**Suncor Energy Cedar Point Wind
Project - Renewable Energy
Approval Amendment
Modification Report**

File No. 160960709

May 2014

Title
Natural Features – Proposed Collector Line - T71 to Townsend Line along Douglas Line and Uttoxeter Road

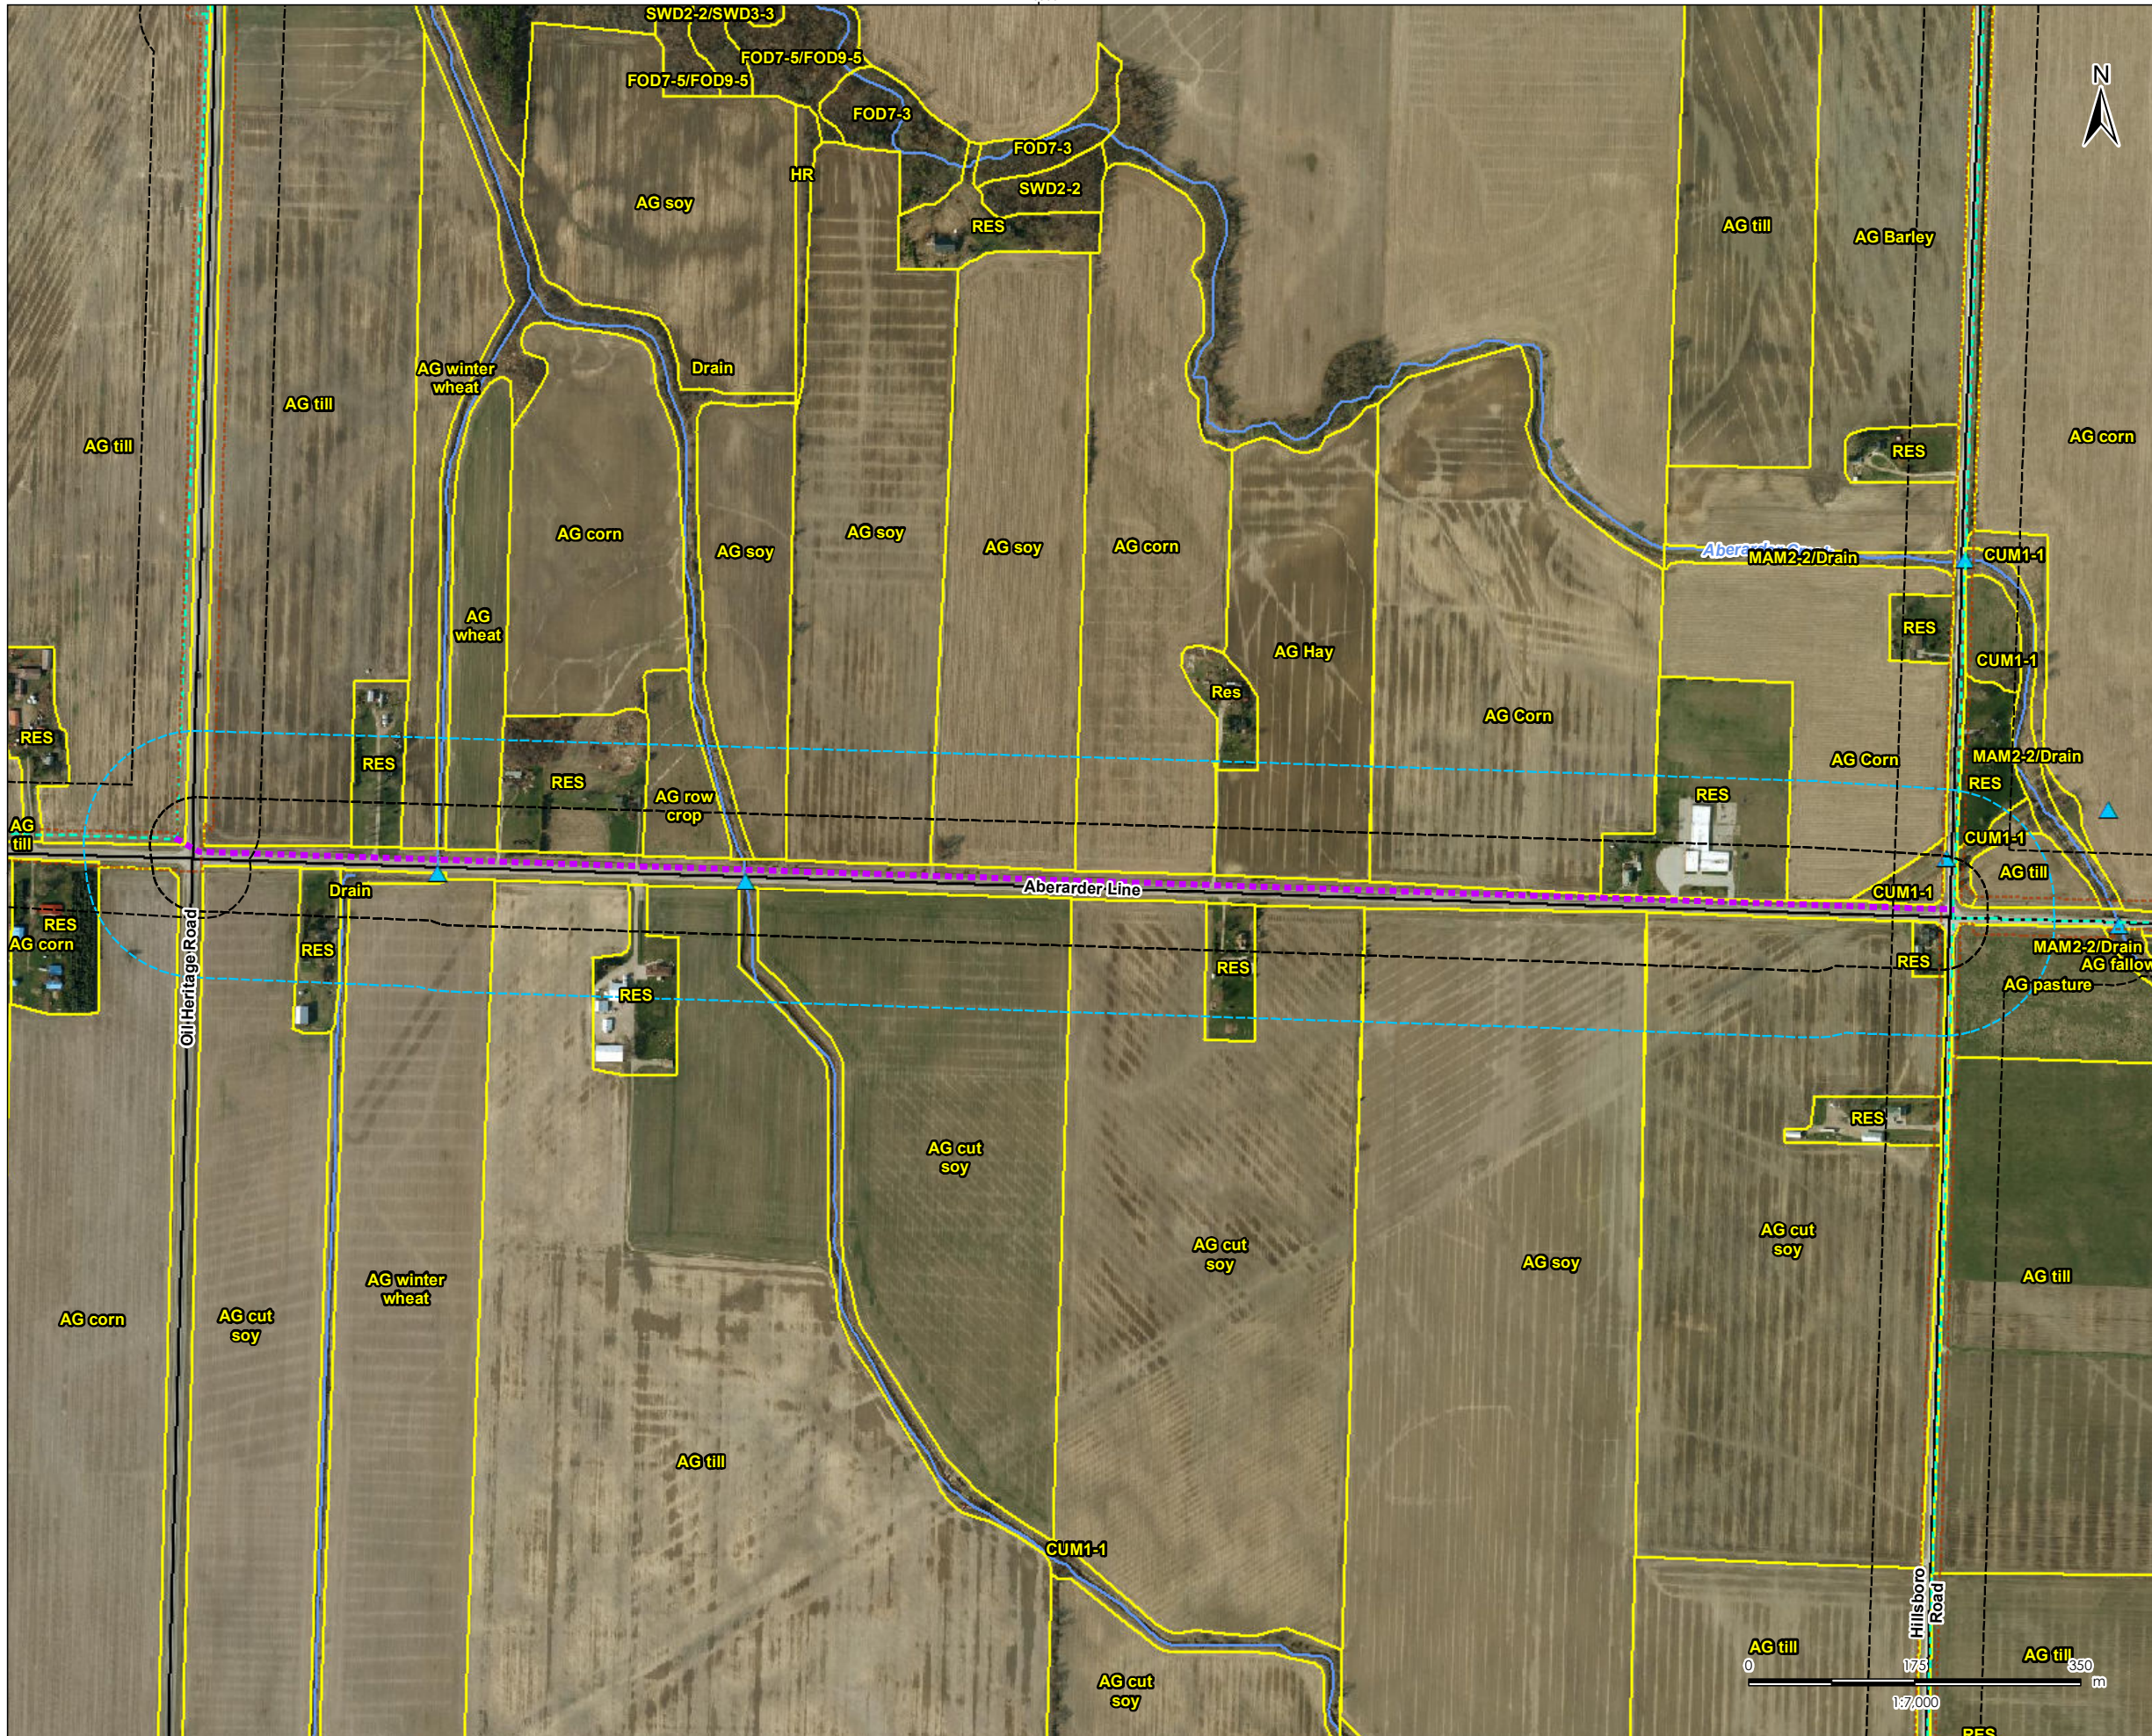
Project Modification 1 involves the addition of an underground collector line along Douglas Line and Uttoxeter Road entirely within the road right-of-way, from T71 to Townsend Line. **Appendix A, Figure 1** shows the location of the modified underground cable location. The addition of the underground collector line route provides Suncor with greater design flexibility and minimizes pinch points with respect to connecting Project turbines with the substation.

One new woodland feature was located within 50 m of the new underground collector line running along Uttoxeter Road. This feature was not identified in the April 2013 NHA/EIS. It is shown on **Appendix A, Figure 1** as new Feature 78. A site investigation of this feature was completed on March 25, 2014. It contains a dry-fresh sugar maple deciduous forest (Ecological Land Classification code FOD5). No candidate wildlife habitat was identified in this feature. This small (0.98 ha) feature is located 29 m from Feature 45 (the woodland to the west of Feature 78) and so is not considered part of the same feature.

Title
Natural Features – Proposed Collector Line - Arberarder Line

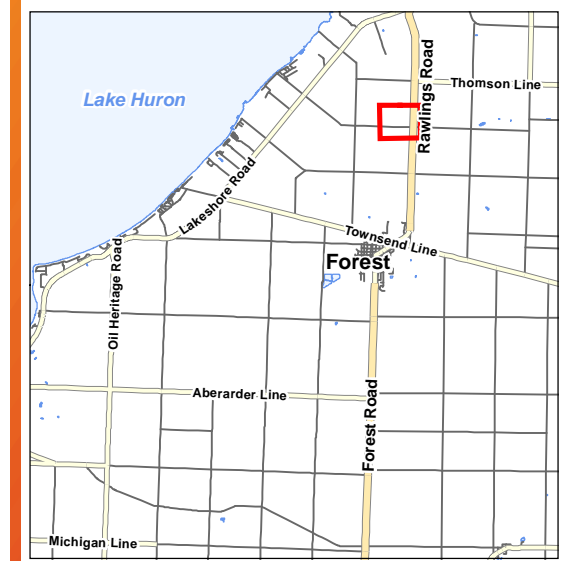
Project Modification 2 involves the addition of an underground collector line along Aberarder Line between Oil Heritage Road and Hillsboro Road entirely within the road right-of-way.

Appendix A, Figure 2 shows the location of the modified underground cable location. The addition of the underground collector line route provides Suncor with greater design flexibility and minimizes pinch points with respect to connecting Project turbines with the substation.

Title
Natural Features- T11- Alternative
Access Road and Collector Route

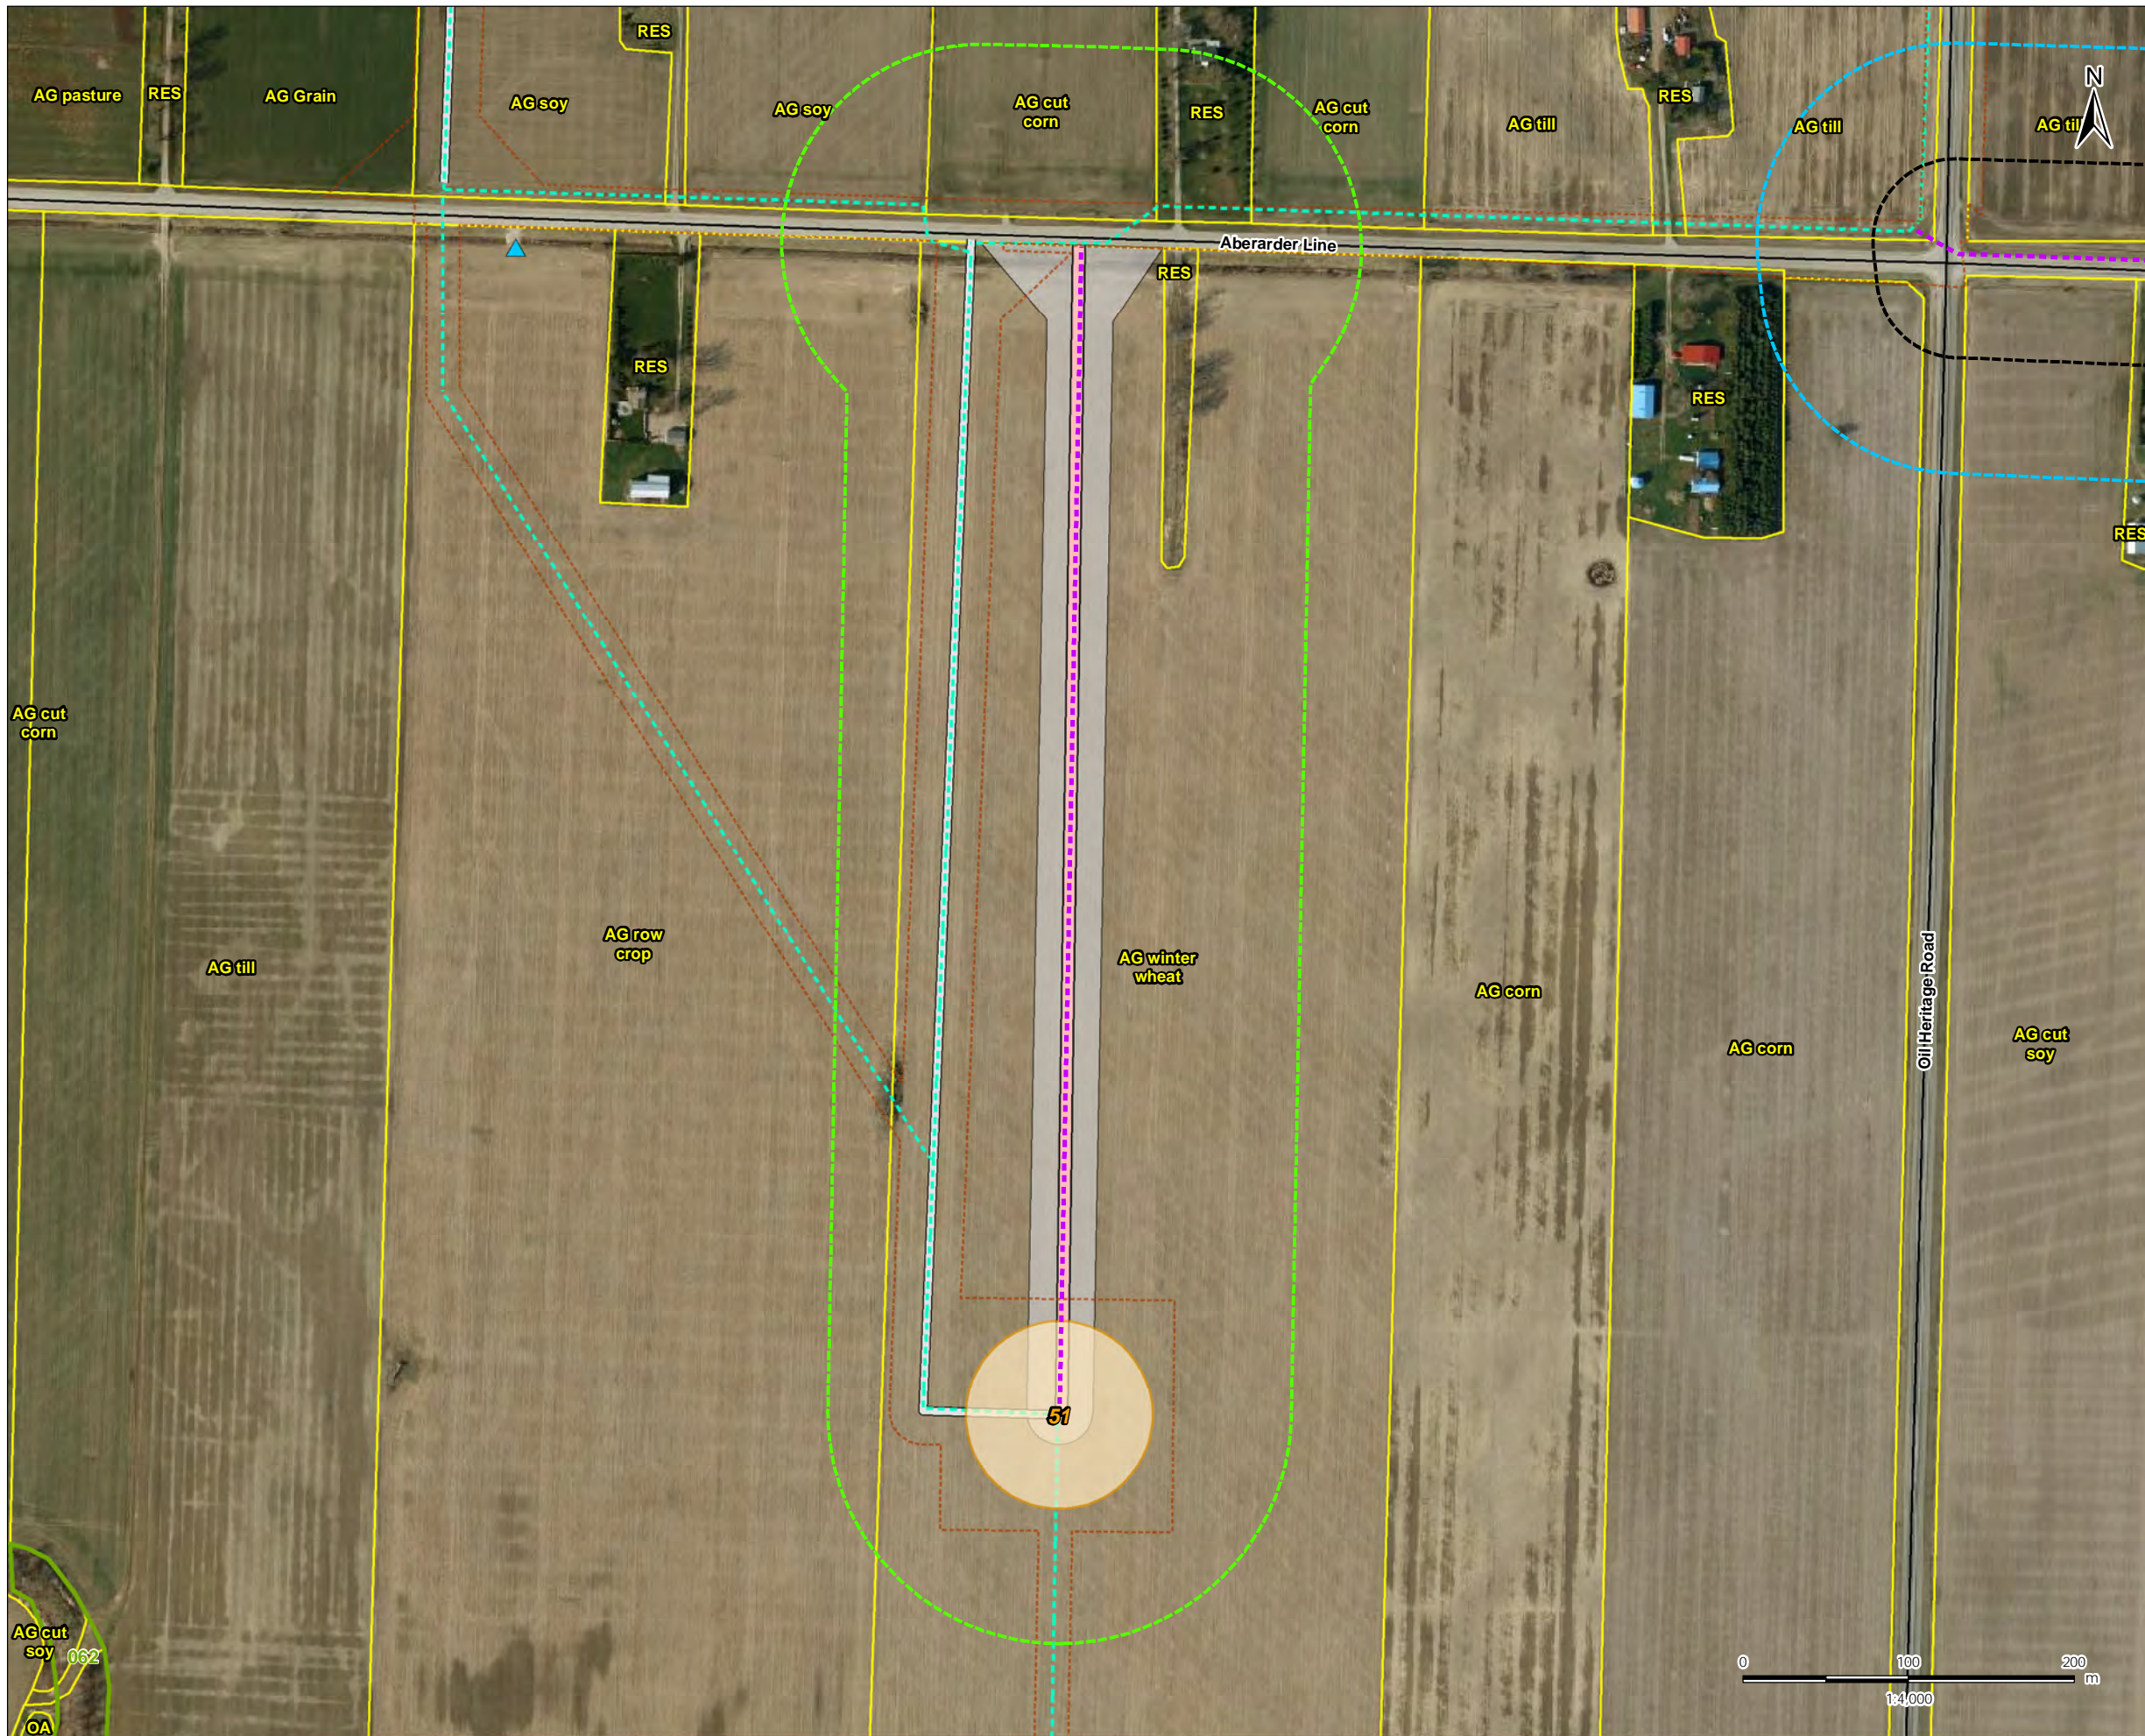
Project Modification 5 moves the location of the access road and underground collector line to Turbine 11 approximately 75 m to the west. Moving this access road and underground collector line moves this location further from Feature 29. **Appendix A, Figure 5** shows the location of the modified underground collector line and access road to Turbine 11. The move is being made by Suncor to address a request made by the participating landowner.
